RESIDENTIAL BUILDING PERMIT APPLICATION

Pole building 12 wide 30x40

From: Oswald, Hank
Sent: Tuesday, May 30, 2023 11:13 AM
To: dryrub1999@aol.com
Subject: B23001864_Pole Building_Site Plan
Attachments: WS_FlorenceRoad_1730_PercApp-2004 (1).pdf

HOUSE LOCATION PLAN

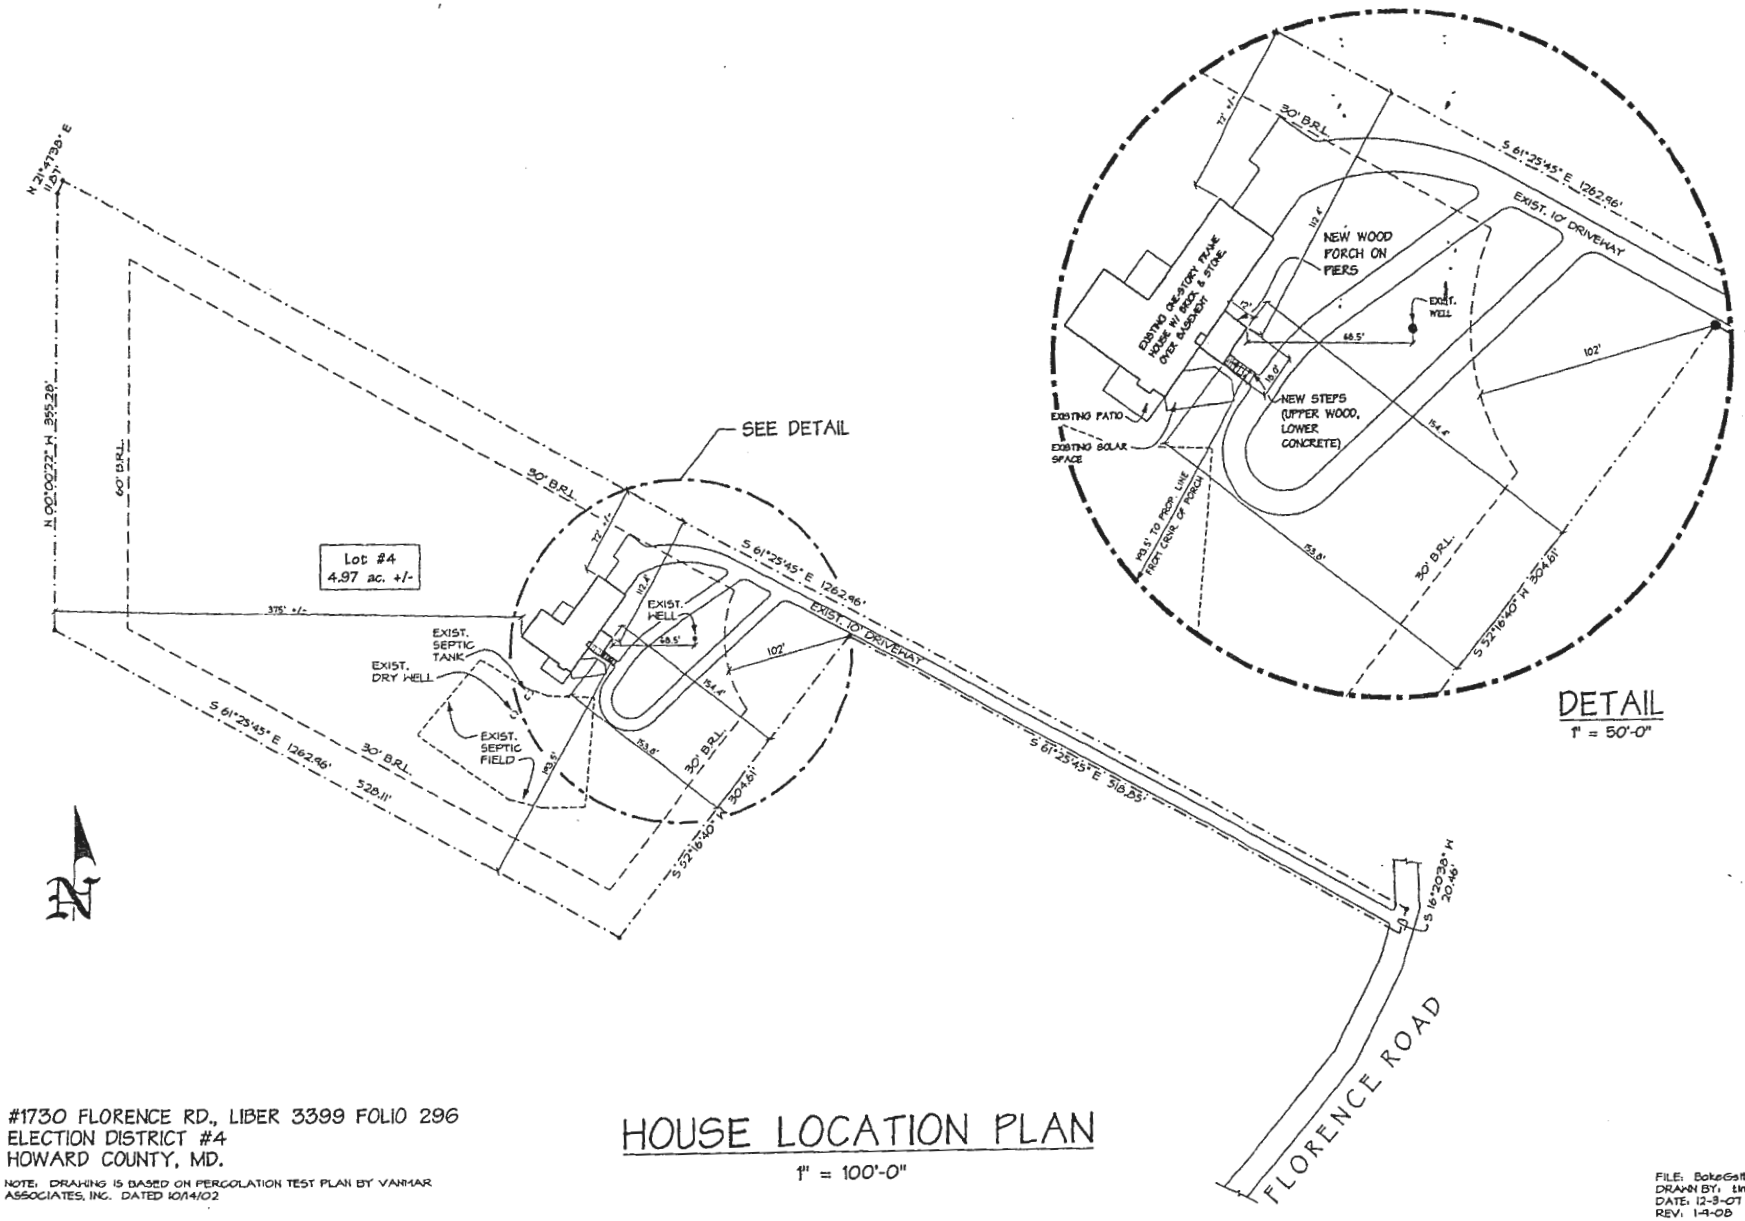
Good morning. This office is in receipt of a building permit for a detached 30 x 40 pole building. Please revise your building permit site plan to include the location of the "septic area" as shown on the approved perc cert plan for Lot 4 (see attached). The pole building must meet the 20 foot setback distance to the "septic area".
